SUBJECT PROJECT CONCEPT REPORT APPROVAL - SR 57 AT OCONEE RIVER OVERFLOW AND DEEP CREEK

BRF-062-1 (13) Washington County
 P.I. No. 221312
 Bridge Replacement SR 57 Over Oconee River Overflow
 and Deep Creek

SUBJECT PROJECT CONCEPT REPORT - Revised

BRIDGE REPLACEMENTS
S.R. 57 (IRWINTON-WRIGHTSVILLE ROAD)
OCONEE RIVER OVERFLOW & DEEP CREEK
BRF-062-1 (13) WASHINGTON

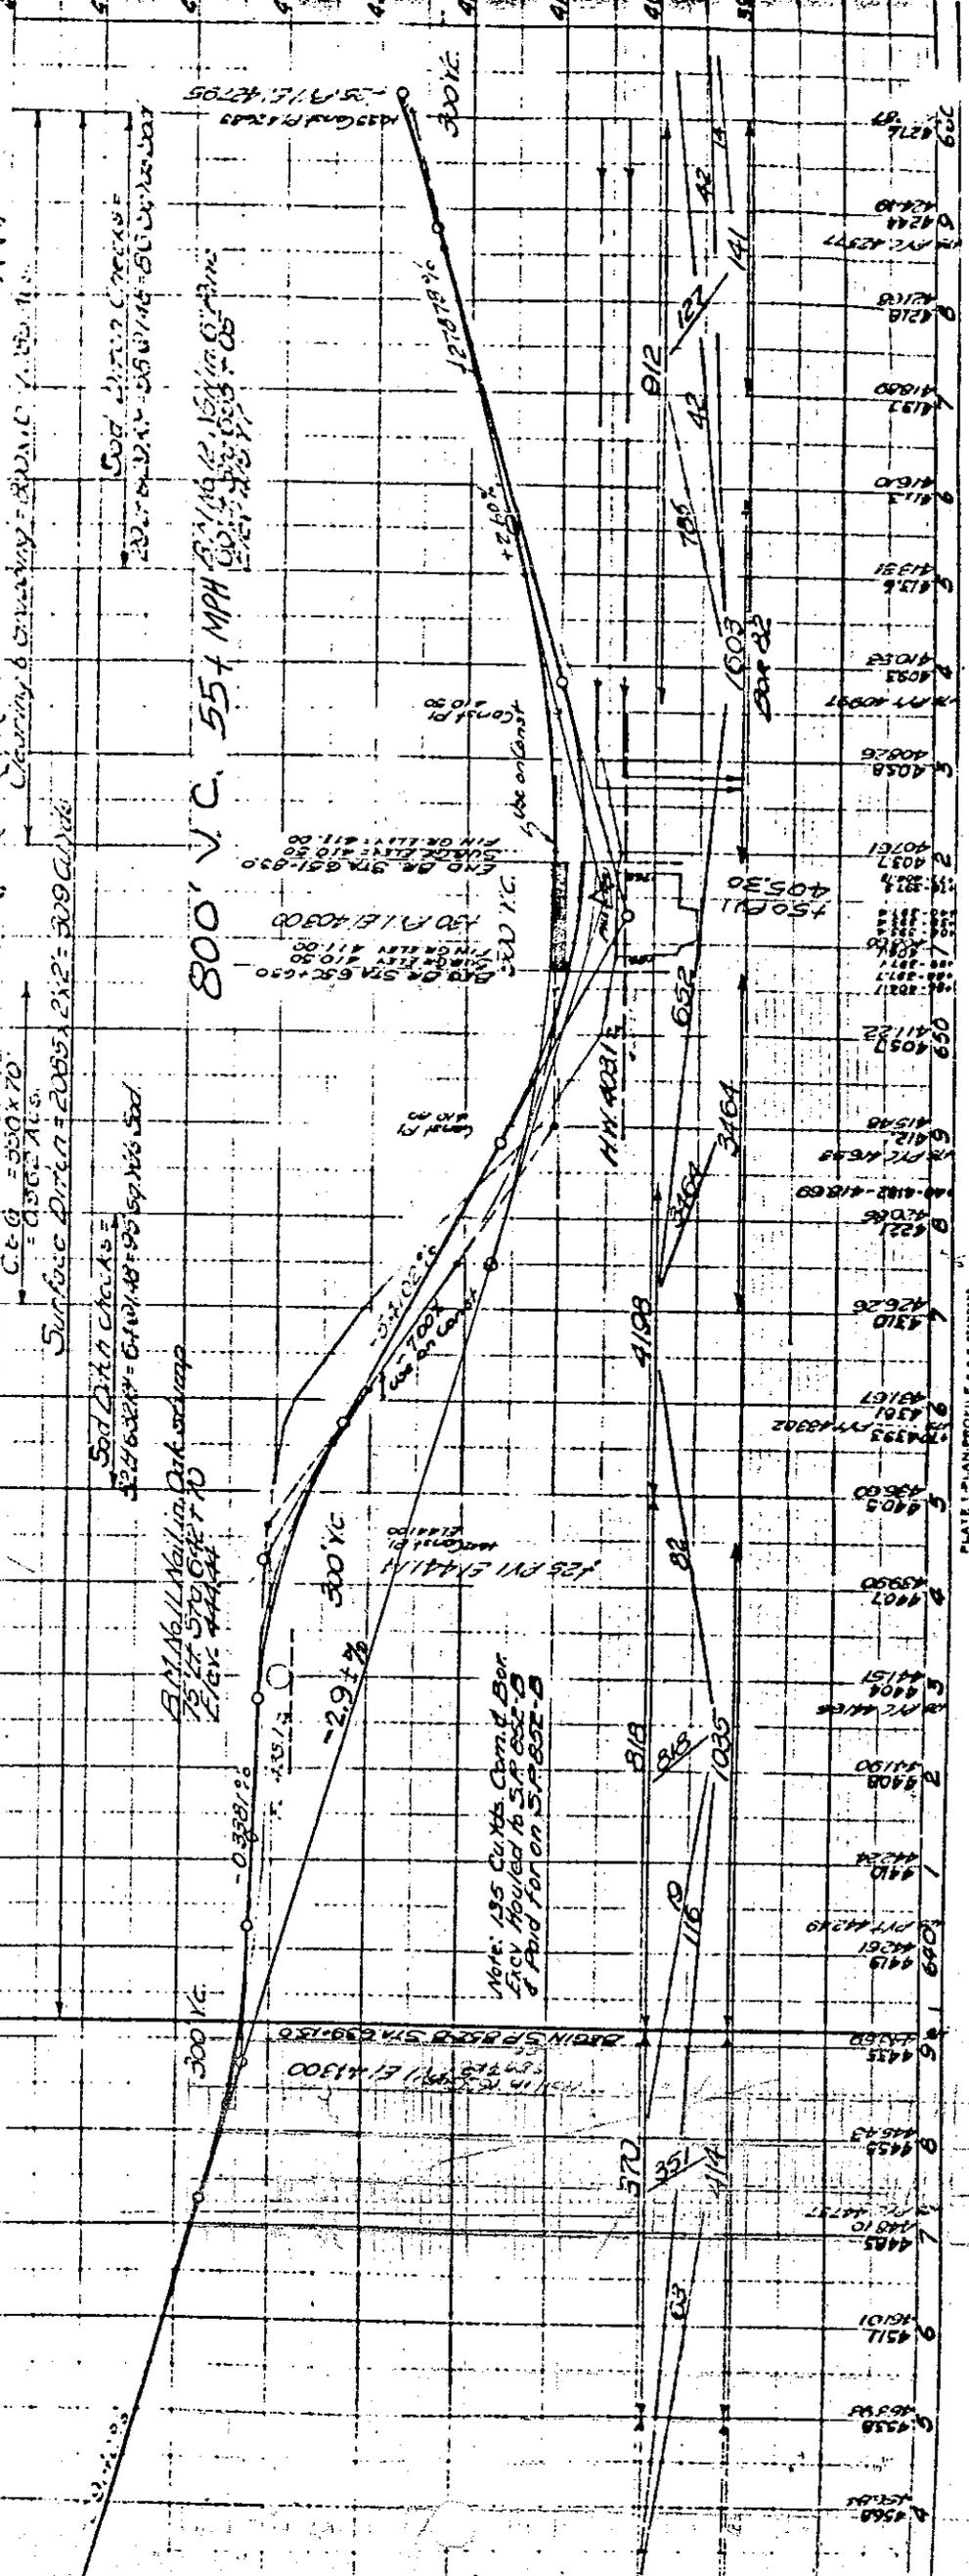
We have reviewed your letter dated July 20, 1989, in which you requested design exceptions for two vertical curves and a 7.0% grade in connection with the bridge replacement on SR-57 at Deep Creek.

We reviewed the project in the field on August 30th and it is our opinion the profile grades should be corrected to the design speed of 55 MPH. The sight distance to the bridge from the west is unrestricted. From the east, the 35 MPH crest vertical curve not only hides the bridge, but it also hides a horizontal approach curve to the bridge as well.

Even though there is no accident history at this site, we believe the 35 MPH crest curve, the 50 MPH sag curve and the 7.0% grade should be increased to 55 MPH. This correction is in compliance with our previously agreed to 3R Standards dated November 4, 1986, paragraph C-2. Our field review indicated these corrections can be made within the existing right-of-way.

In summary, your request to retain the 35 MPH crest vertical curve, the 50 MPH sag vertical curve and the 7.0% grade is denied.

Attached is revised project concept report for the noted project. The concept report is revised to correct the vertical alignment at the Deep Creek site to meet 55 MPH speed design. The vertical alignment correction is necessary because the design exception request was denied by the FHWA. As you will note from the layouts the horizontal alignment is also being changed, this is necessary to achieve the best overall horizontal and vertical alignment at this site, thus eliminating the need for an on-site detour and lowering the overall cost.
